ADDENDUM

Project: Hillcrest 1, 2 Roof

Addendum No.: 3

Date: 6 May 2022

S5.01

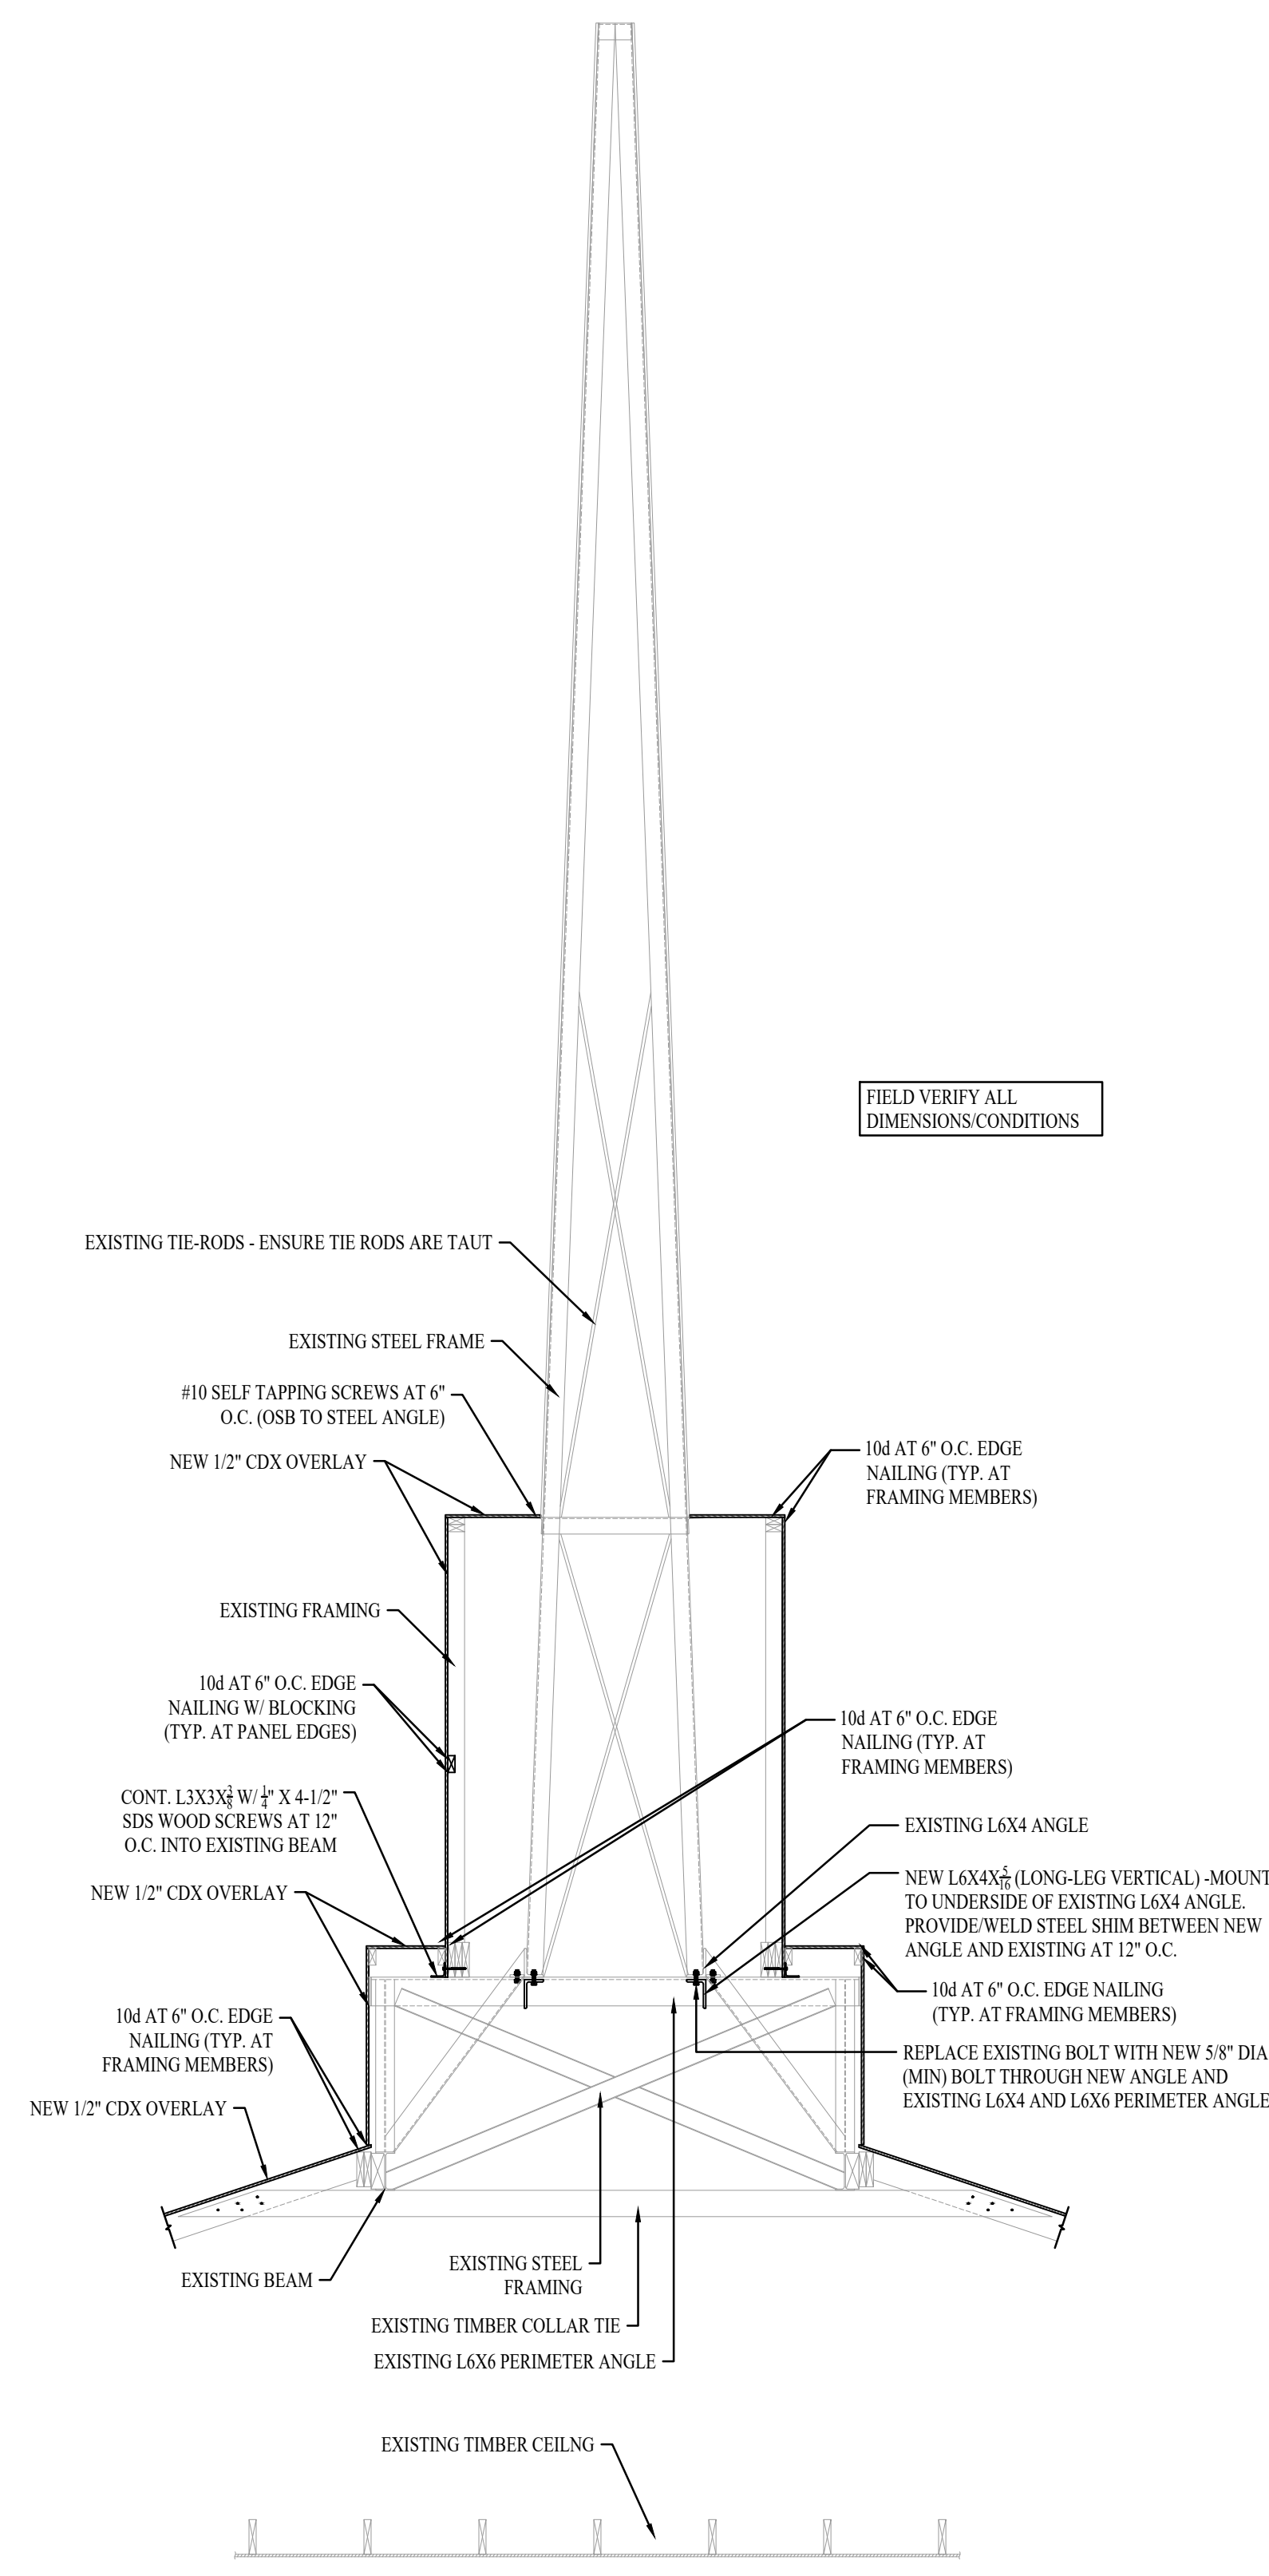
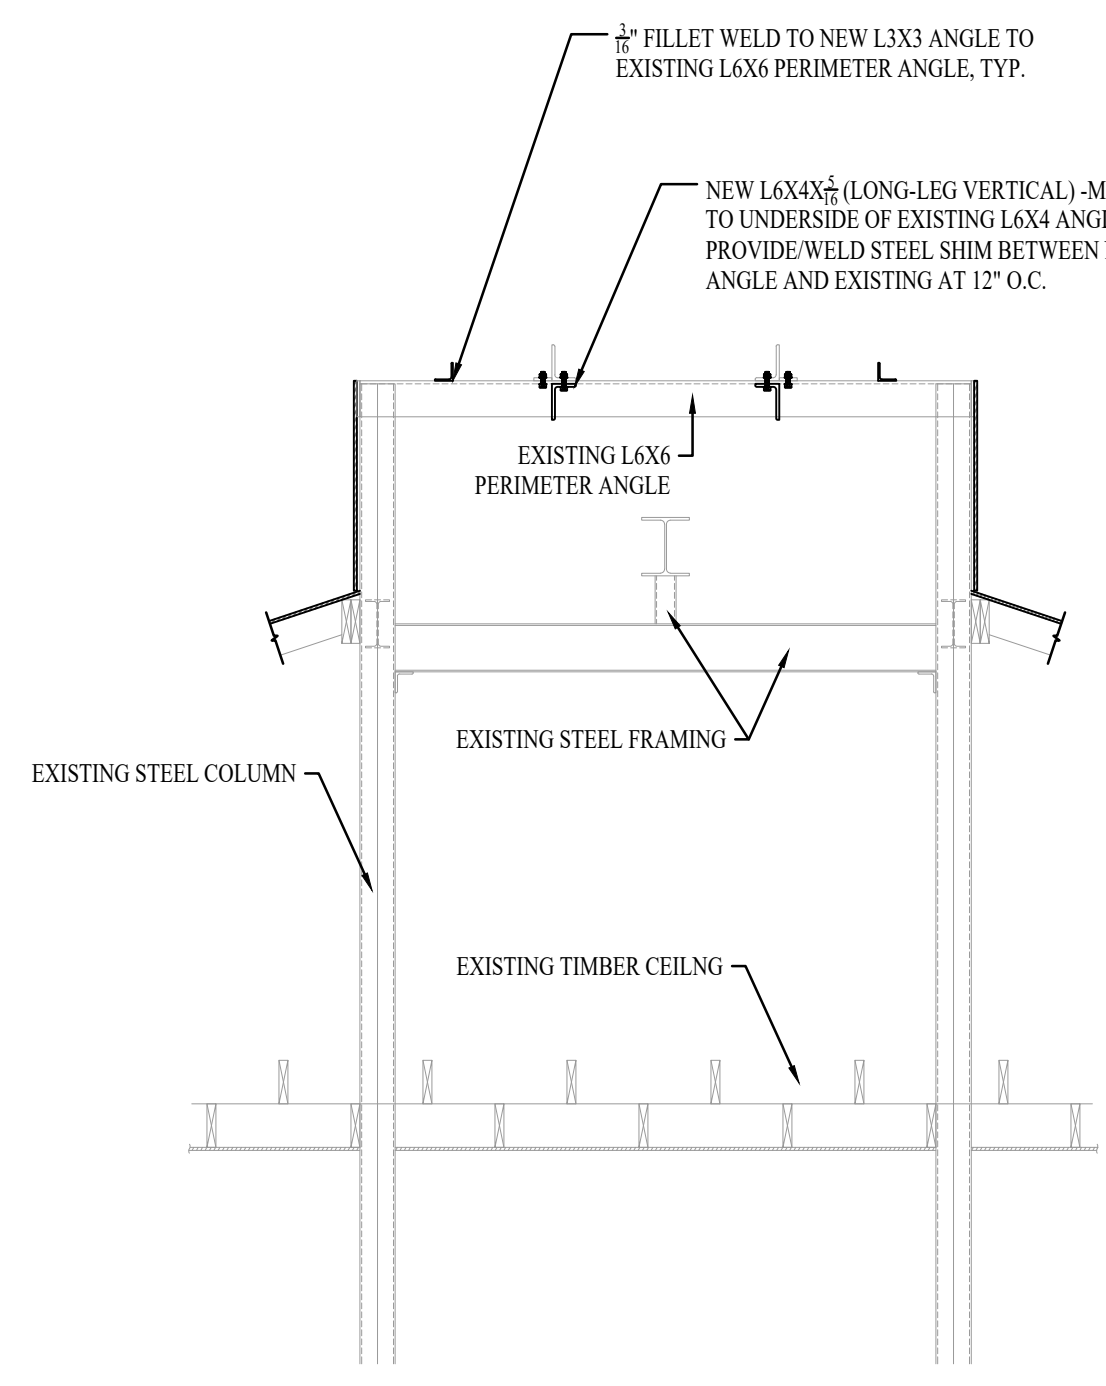
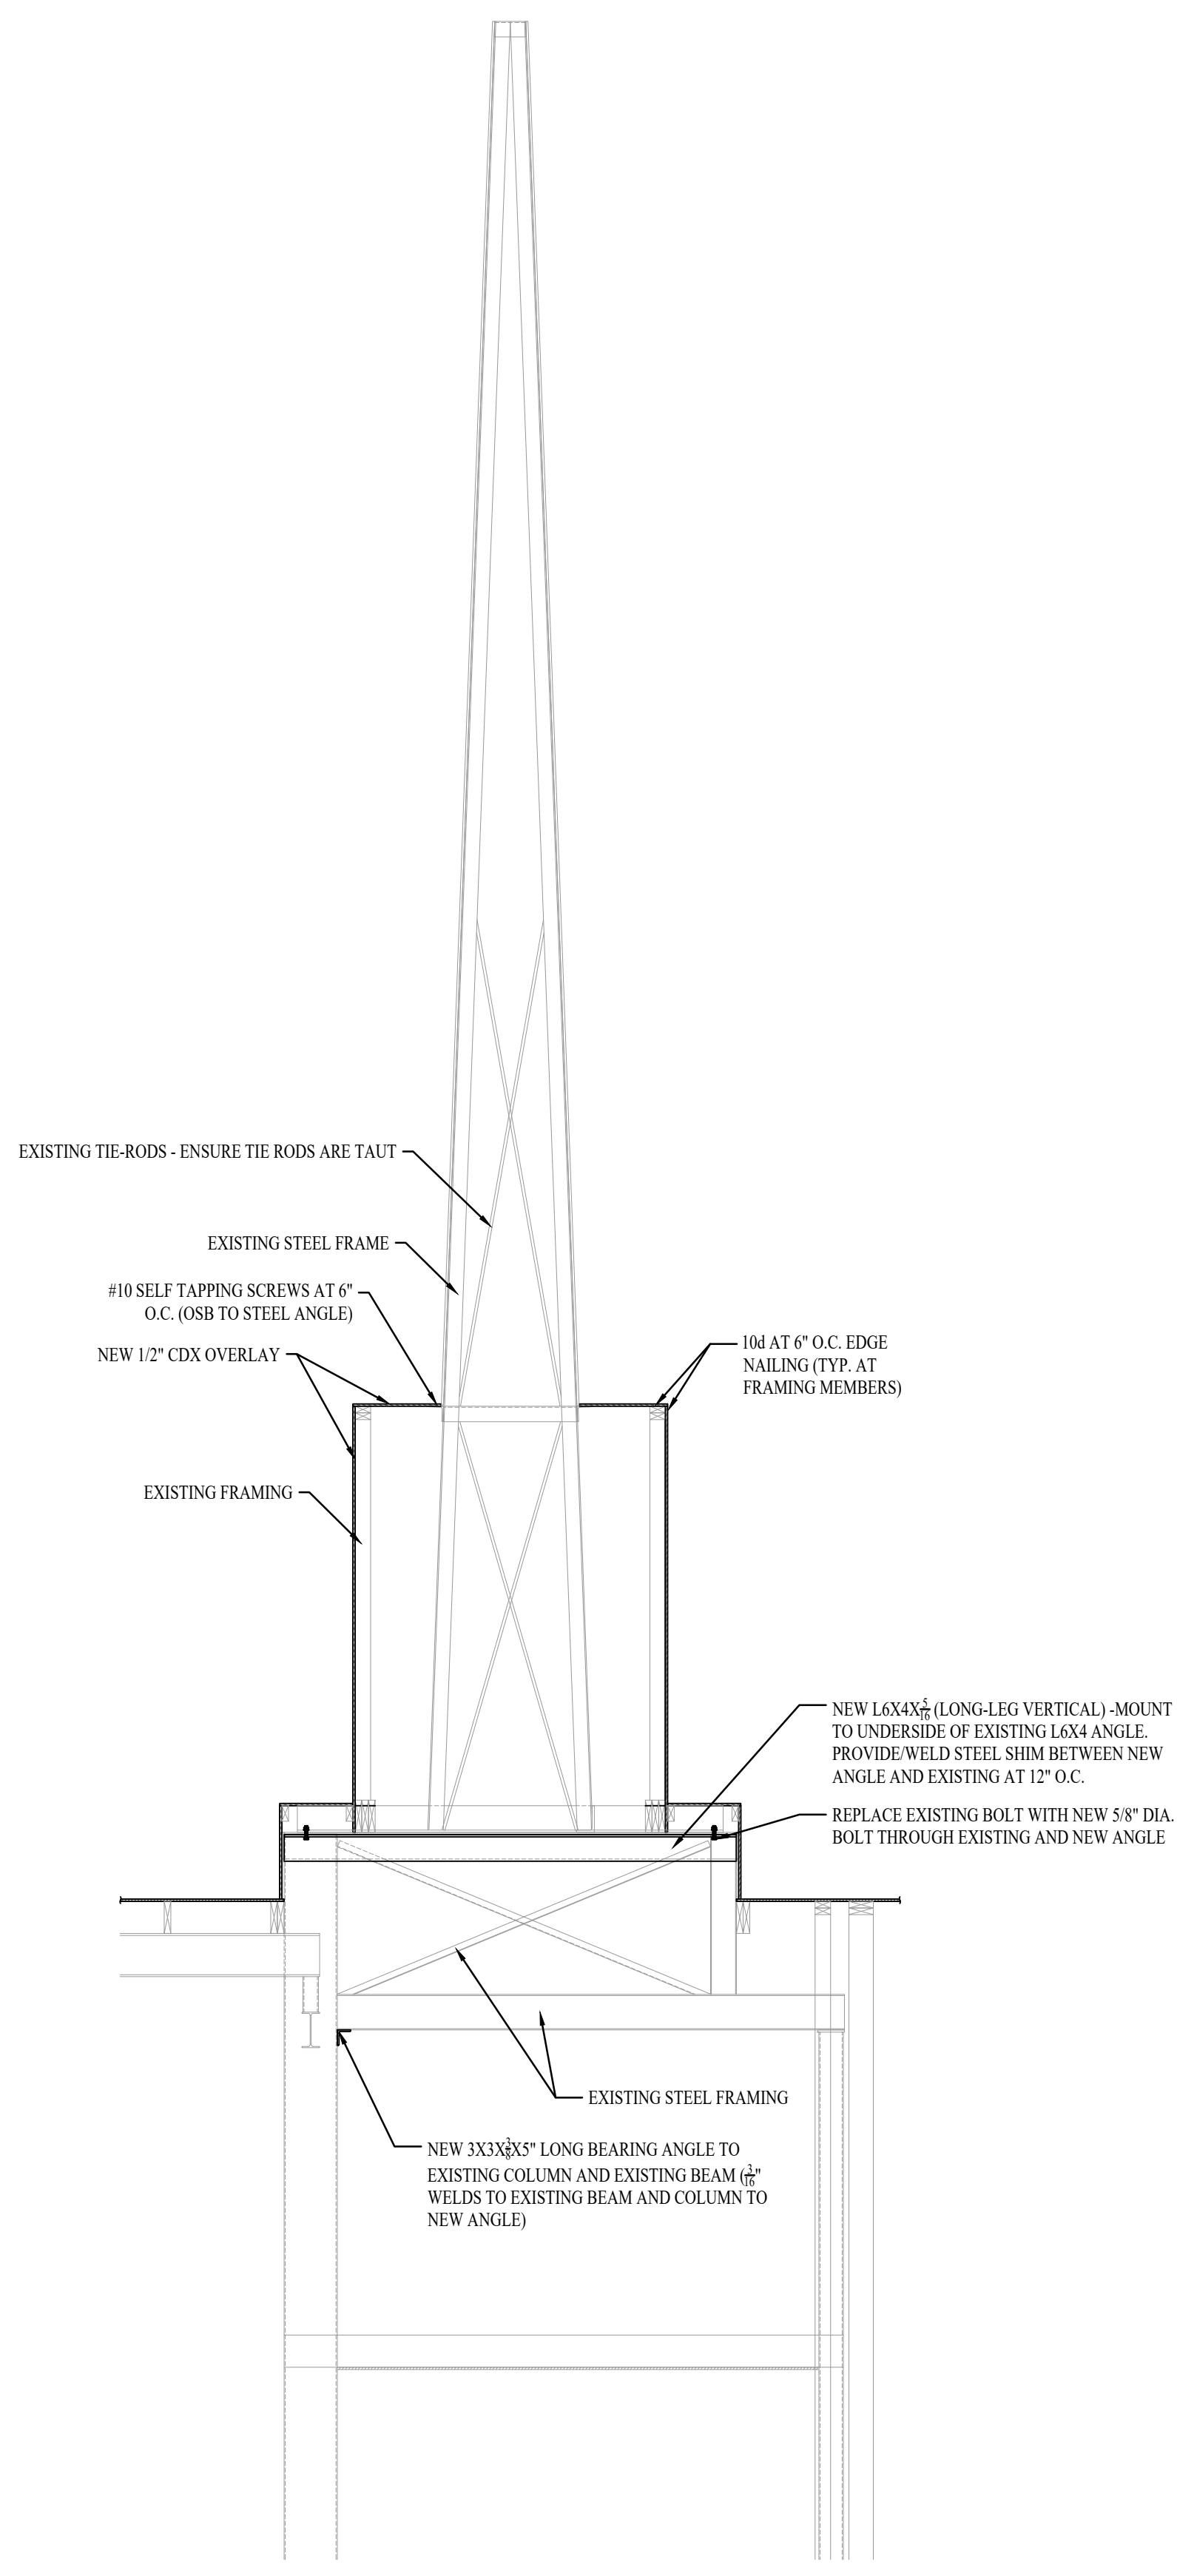
- a. After further review, the engineer has determined that there is no need to remove the metal siding on the uppermost portion of the steeple (the upsidedown ice cream cone portion). Contractor is to preserve and protect this portion of the steeple while removing and installing required elements on the bottom portion. See attached sheet with revised details.
- b. Note 3 on sheet S1.00 requires that the sistered 2x members extend from the ridge down to the eave on the top chord of the trusses and for the rafters.
